#### **ADDENDUM #4**

PROJECT : CODESTACK ACADEMY

REF. # : ARCH PROJ. No. 2023-04

DATE: 11 March 2025

S4.1

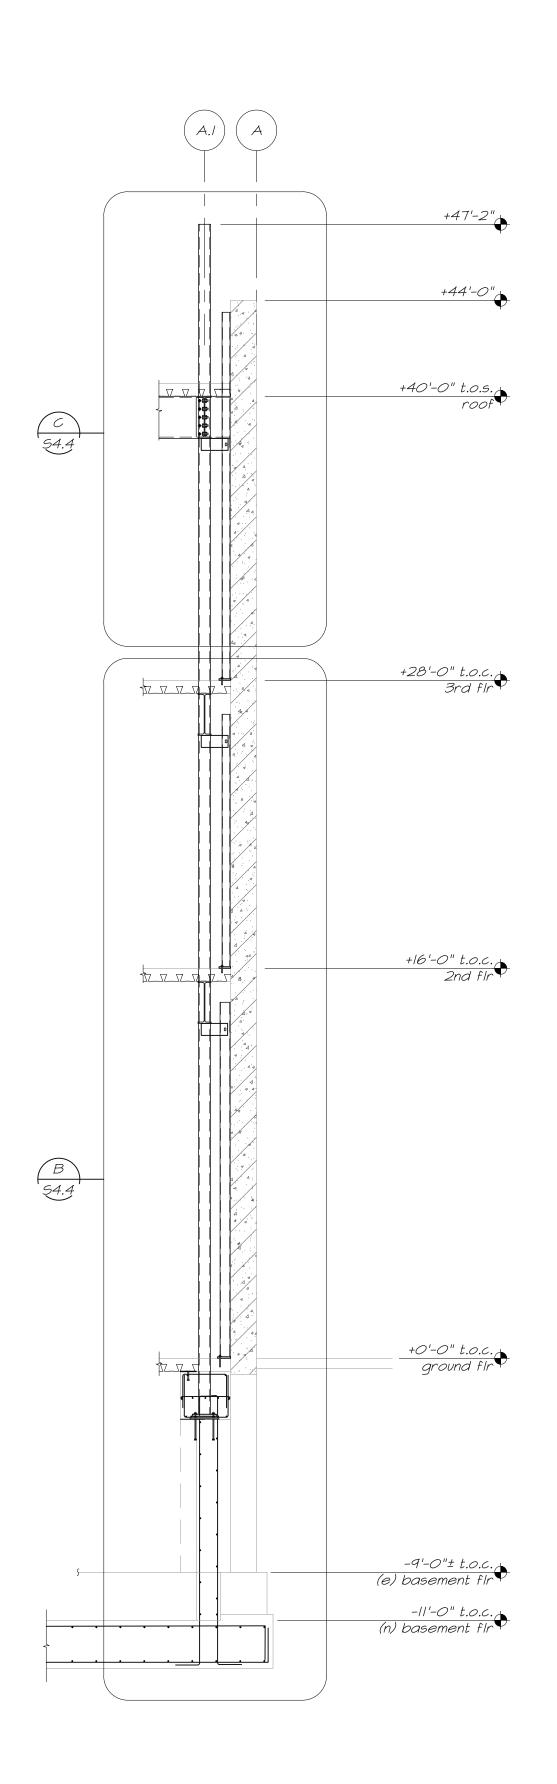
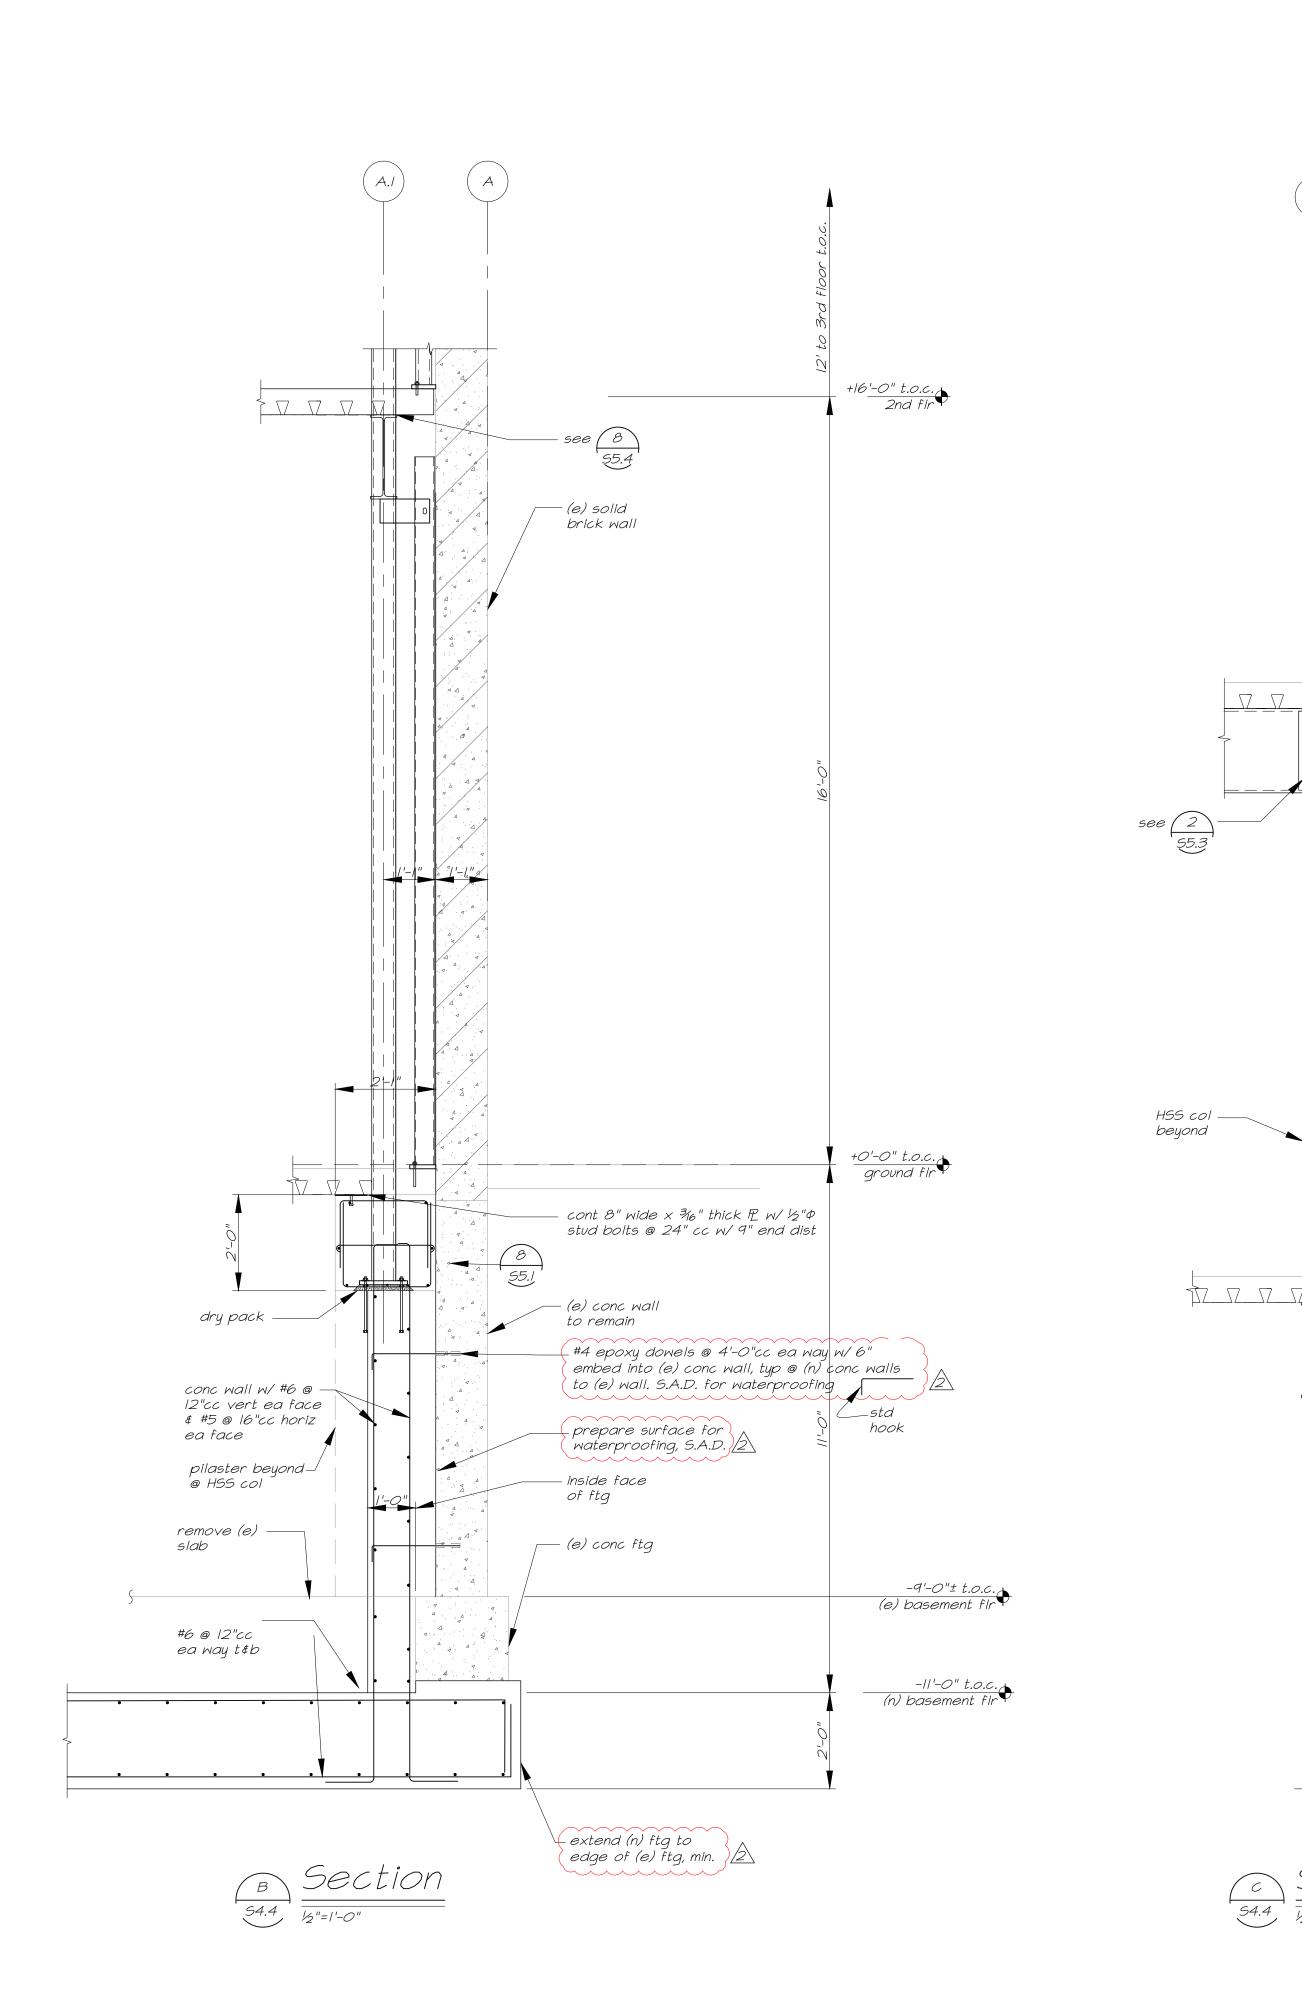
**ITEM 37** QUESTION (02.28.25): Structural details do not include epoxy dowels at (N) concrete walls attached to (E) brick walls. Will this be required?

**ITEM 38** QUESTION (02.28.25): Will (E) wall surfaces at new concrete need to be sand blasted, water blasted or roughened?

<u>RESPONSE:</u> Structural note to address this question has been added to attached sheets S4.1, S4.4 & S4.5.

<u>RESPONSE:</u> Prepare surface to receive blind side waterproofing. Note added to attached Structural sheets S4.1, S4.4, S4.5. also Added notes for dowels to connect new and existing walls and extended footing.

**DESCRIPTION:** Add note for B deck at trash enclosure. Added trash enclosure roof deck to 5/S5.4.

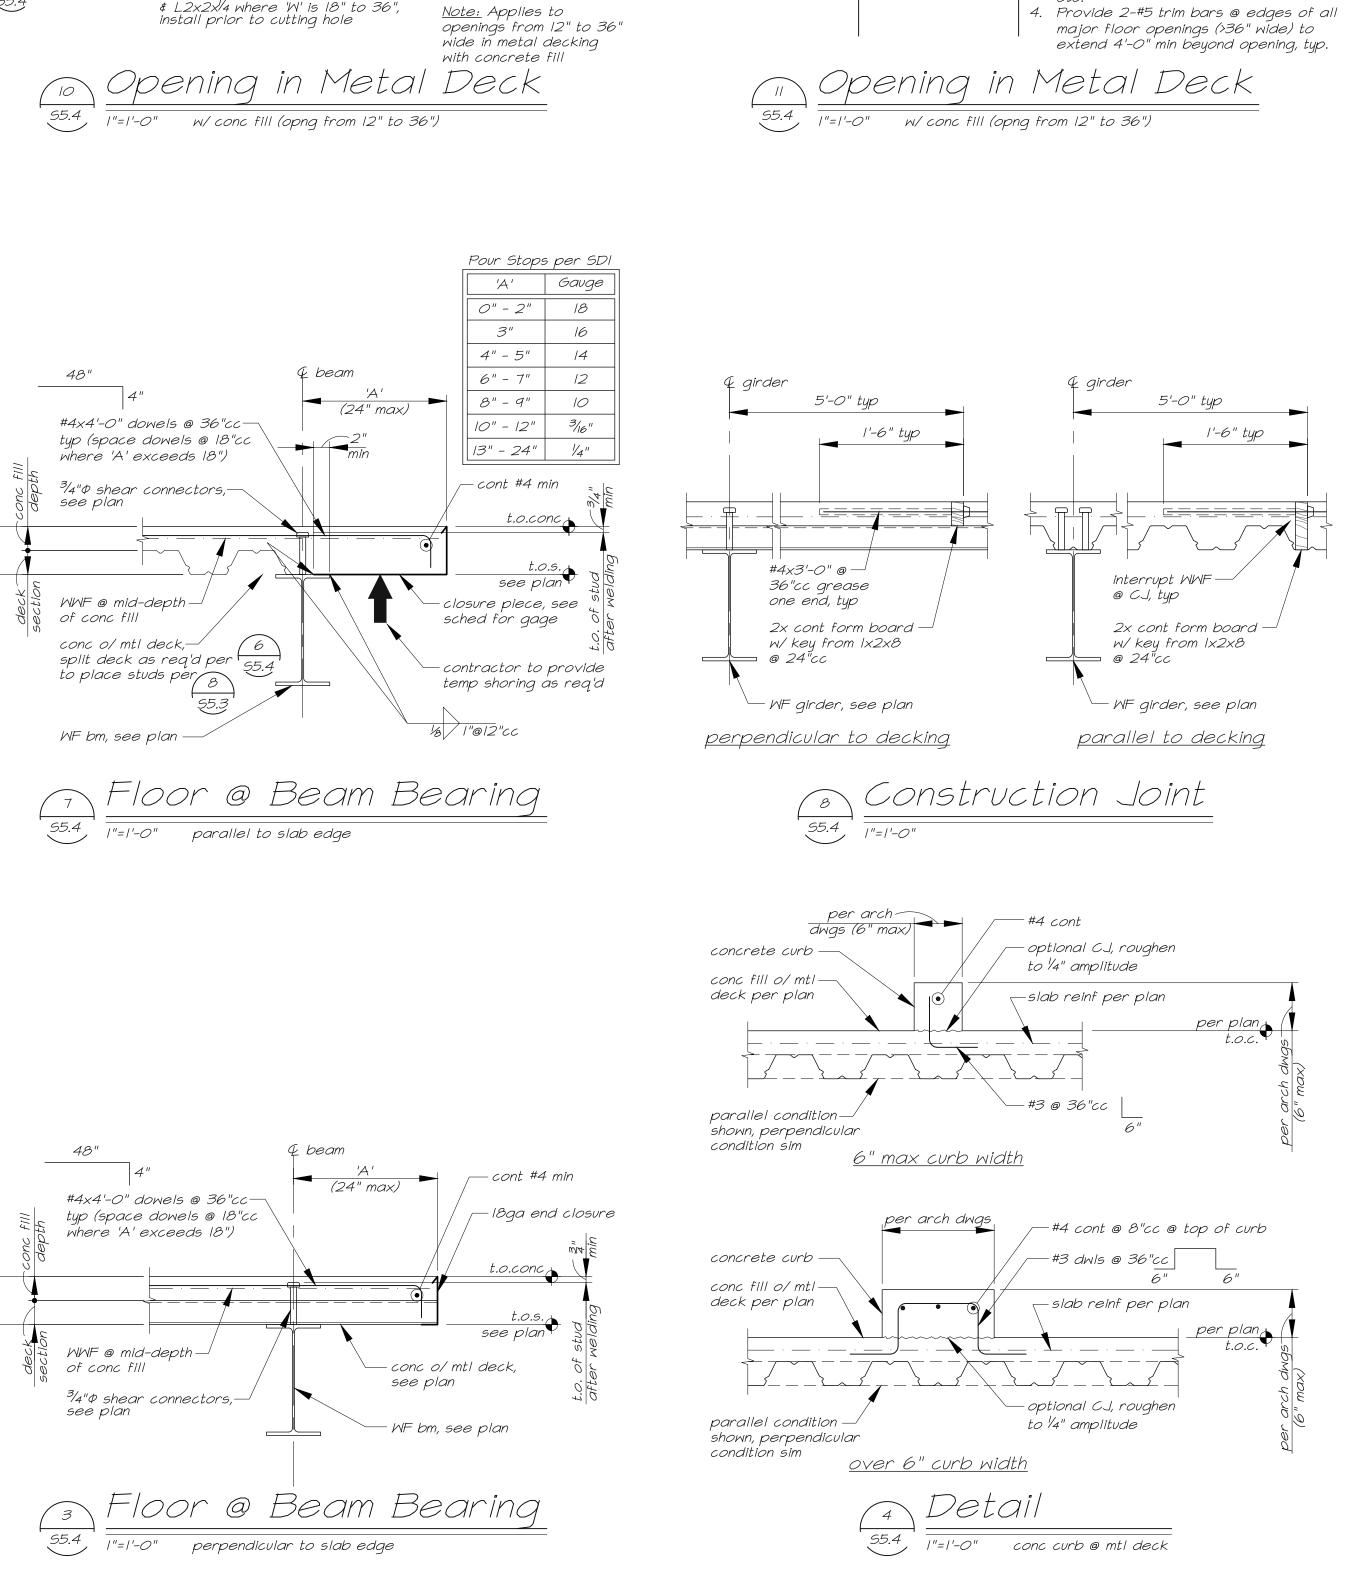
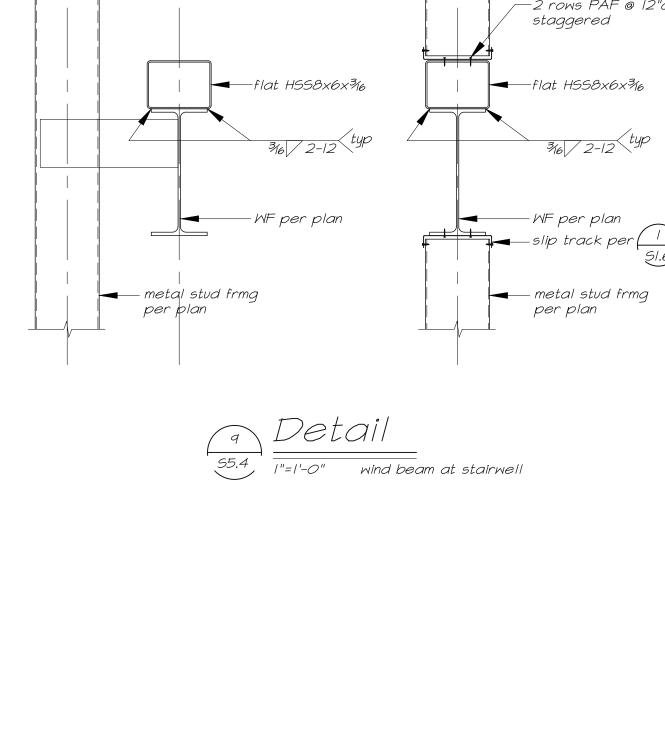
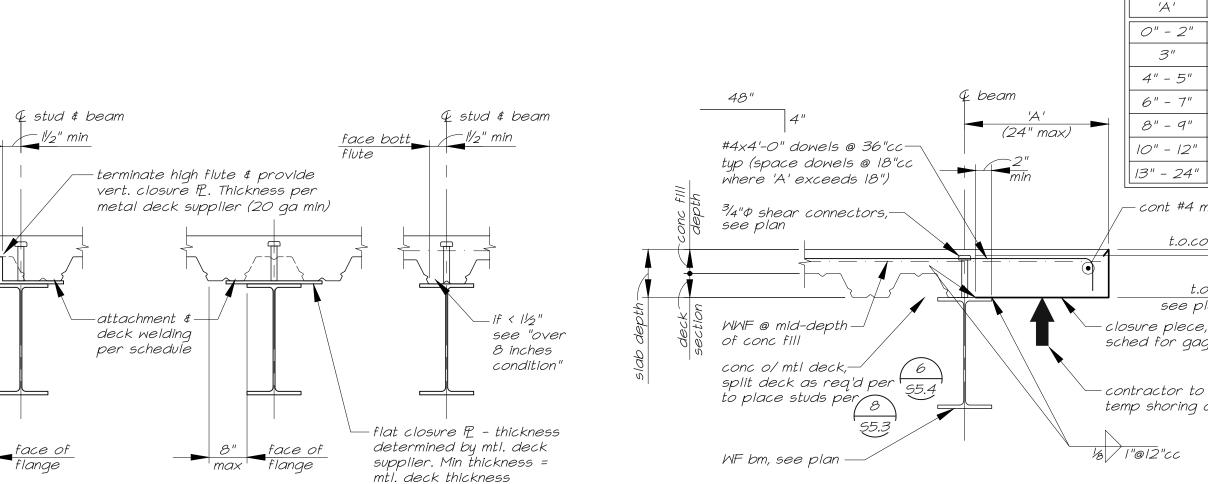
**ITEM 39 Drawing sheet:** S5.4 (attached)
